JAR-22: SAILPLANES AND POWERED SAILPLANES

Please find attached a copy of Amendment 1 to JAR-22, effective 1 August 2001.

JAR-22, Amendment 6, 1 August 2001

FIGURE 3 PITCHING MANOEUVRES

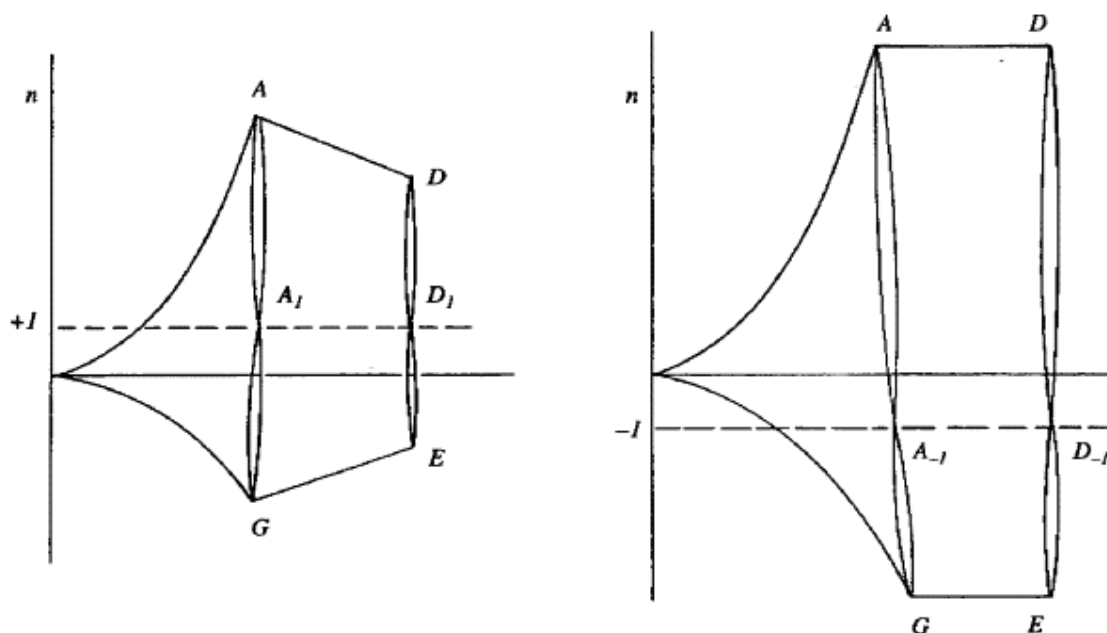
- (a) The introduction of NPA 22C–6, which:–
- (i) corrects the signs in the 'Load Factor Increment' column in the table of Category A – Additional Cases on page C–8; and
 - (ii) indicates manoeuvring load factors n_1 to n_4 in Figure 1, Manoeuvring Envelope, referred to in paragraph JAR 22.333(b).

FIGURE 1 EXAMPLE OF AIR SPEED INDICATOR MARKINGS

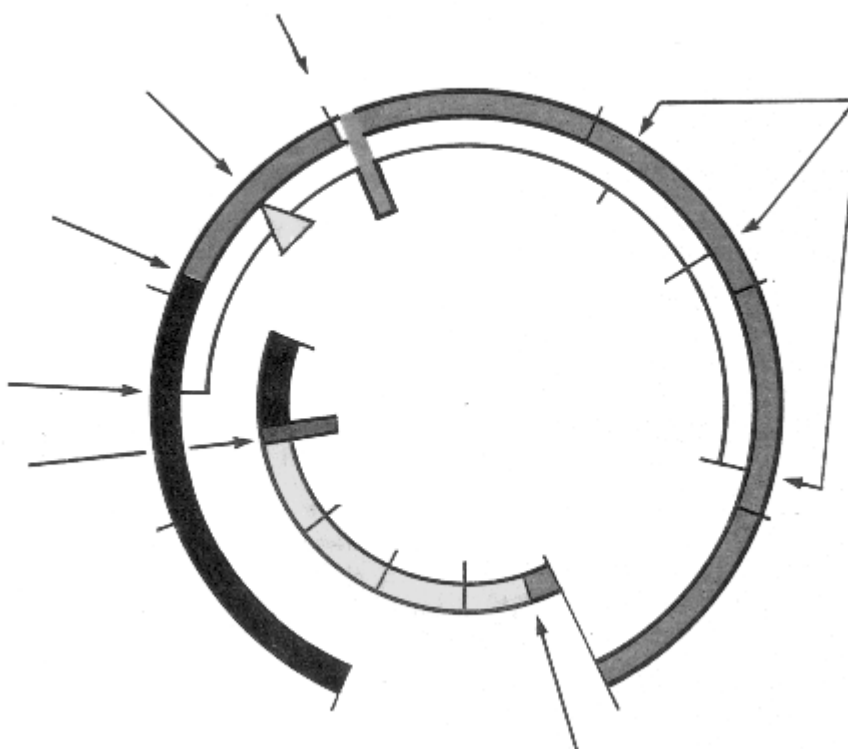
Editorial amendment to the caption of Figure 1 to clarify that the Figure is an example of airspeed indicator markings.
